Process Sheet

Customer : CU-DAR001 Dart Helicopters Services Drawing Name : 350 SKIDTUBE ASSEMBLY LH
 Job Number : 47397 ✓
 Estimate Number : 10262
 P.O. Number :
 This Issue : 23/04/2009 S.O. No. :
 Prsht Rev. : NC Part Number : D350636011 ✓
 First Issue : // Type : SKIDTUBES Drawing Number : D2750 REV F
 Previous Run : 47037 Drawing Revision : F
 Material :
 Due Date : 08/05/2009 Qty: 1 Um: Each
 Written By :
 Checked & Approved By : JLD 09.04.23
 Comment : Est Rev:J 02.09.25 Rearranged procedure steps KJ
 Est Rev:J 06-03-23 As per Rev D JLM
 Est Rev:K 06-07.13 As per dsi9343 EC
 Est Rev:L 07-07-28 Added SS Wearplates(Rev E) JLM
 Verified By:EC
 Est Rev:M 08-04-22 update steps 4, 13 DD verified by:EC
 Est Rev:N 08-09-23 revF as per dwg DD verified by:ec
 Est Rev:O 09-02-06 apply antiseize on AN8C21A bolts as per
 PAR09-010 DD verified by:EC

DRAWING NO. D3492	TITLE PLUG	REV. C	DART AEROSPACE LTD ENGINEERING ORDER		D.E.O. NO. D3492-C-1	SHEET NO. SHEET 1 OF 1	SCALE NTS
DRAWN AJS	CHECKED	MFG. APPR.	APPROVED		DE APPR.		
DATE 08.11.05	DATE 08.11.05	DATE 08.11.05	DATE 08/11/05		DATE 08/11/05

D3492-XX PLUG MACHINING DETAILS

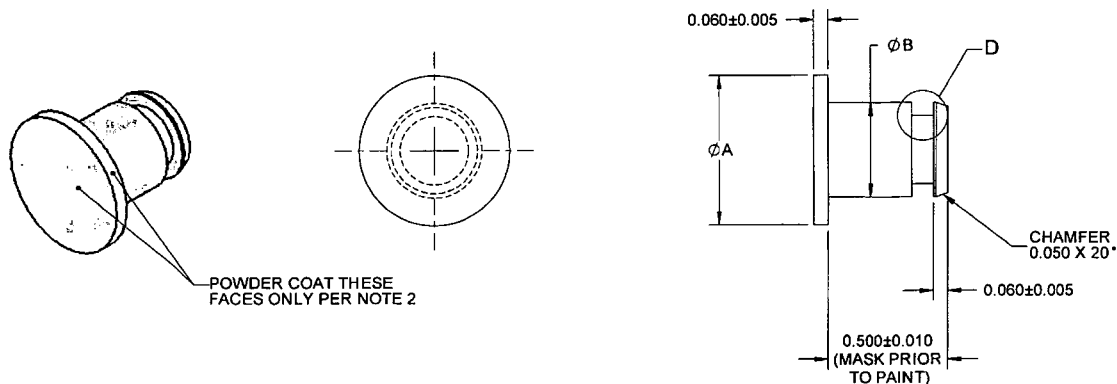
SHEET 2 MODIFY -13 PLUG AS SHOWN:

IS:

P/N	A	B	C	MATERIAL SPEC
D3492-13	0.750	0.510	0.045	M6061T6R0.750

WAS:

P/N	A	B	C	MATERIAL SPEC
D3492-13	0.750	0.520	0.045	M6061T6R0.750
